TECHNICAL NOTE

WINGS NURSERY, LIDSEY ROAD, WOODGATE, WEST SUSSEX

Response to West Sussex County Council Highway Comments.

Ref: ADMA/17/3711s

Site Location & Accessibility Plan

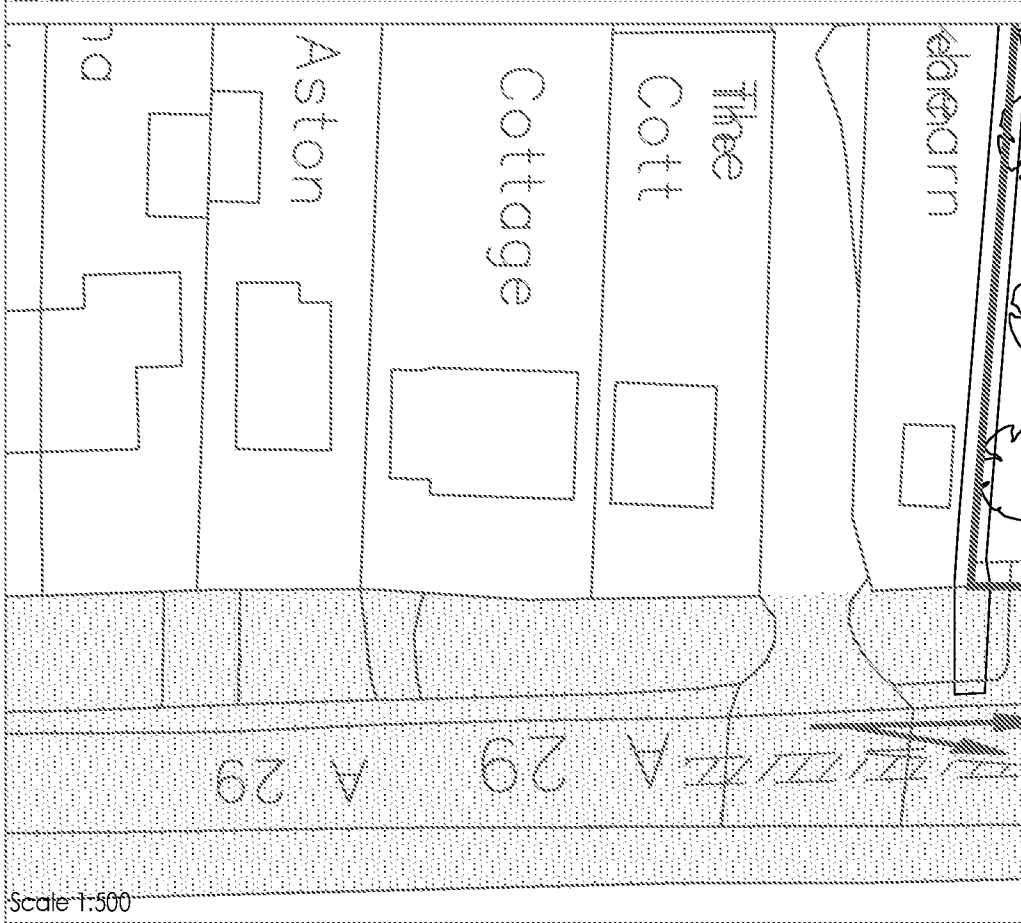
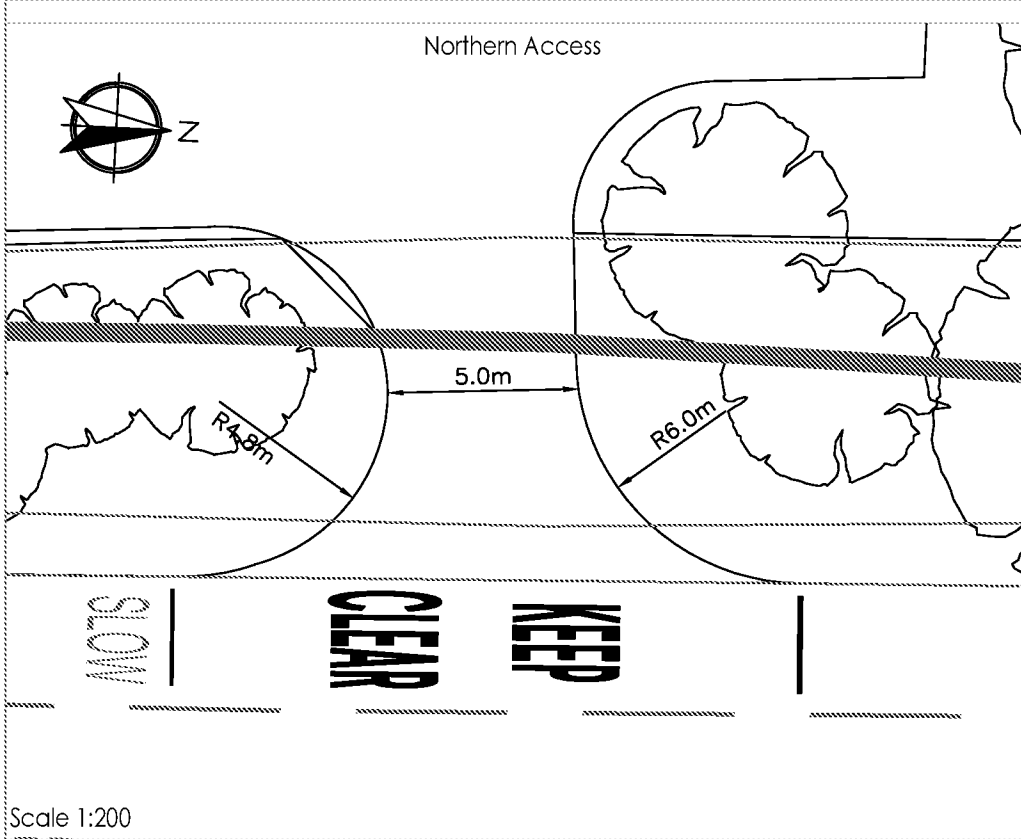
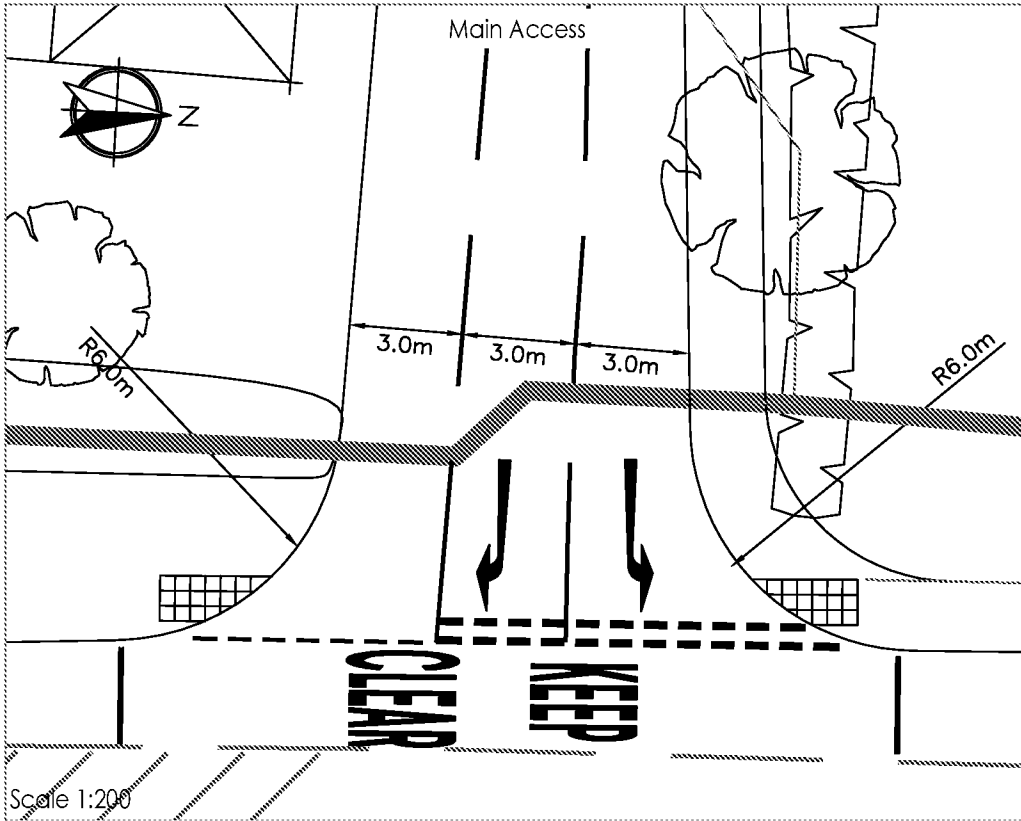
The development site is located in the village of Woodgate which forms the southern part of an almost continuous ribbon development northwards along the A29 and eastwards along the B2223 comprising the villages of Westergate, Eastergate and Barnham. It is remote from existing major employment centres in Bognor Regis, Chichester and Littlehampton although there are a number of smaller local employment centres in the aforementioned villages. In terms of transport sustainability, the site is not well located being on the edge of the settlement boundary and remote from the nearest railway station at Barnham. The level of bus service passing the site is also limited and the main cycle and pedestrian routes are along the busy A29. Cyclists have to share limited road space with other traffic. Pedestrians have to walk adjacent to traffic along the main road – in places where footways are narrow – and have no assisted ways to cross the A29 which if provided, could provide some access opportunities to formal Public Rights of Way (PRoW) leading towards Barnham and its railway station.

Given the above, there is again conflict with the NPPF. The lack of suitable pedestrian facilities was identified previously by the Highway Authority in connection with the previous Woodgate Centre planning applications and reiterated at the subsequent Planning Appeals. This was acknowledged by the Inspectors when considering the latter.

- 2.21 In the immediate vicinity of the site the existing community is supported by convenience facilities, local schools, and leisure facilities. As demonstrated in Plan 01 (attached) the site provides pedestrian and cycle connectivity to these services. The applicant is happy to cooperate in providing crossing facilities as required by the LHA, where cost effective and the level of mitigation offered is justified.
